Access Compliance Report Public Rights-of-Way (Pedestrian Signals)

Main Street: CROWN_VALLEY_PKWAY Cross Street: CROWN_VALLEY_PKWAY Location: NW

ADA ID: SGRK211026120543 Signal Type: One Push Button-Non APS Overall Compliance: No Severity Scores: BTN 1: 35 BTN 2: N/A No BTN: N/A

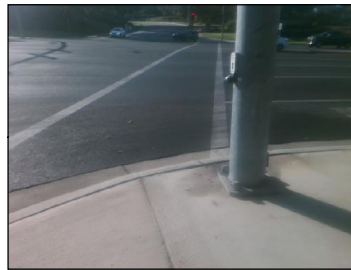
OC Std/PROW: R404.2, R404.3, MUTCD 4e.08

Possible Solutions: Replace Signal Push Button With APS Button. Remove and Replace Clear Space.
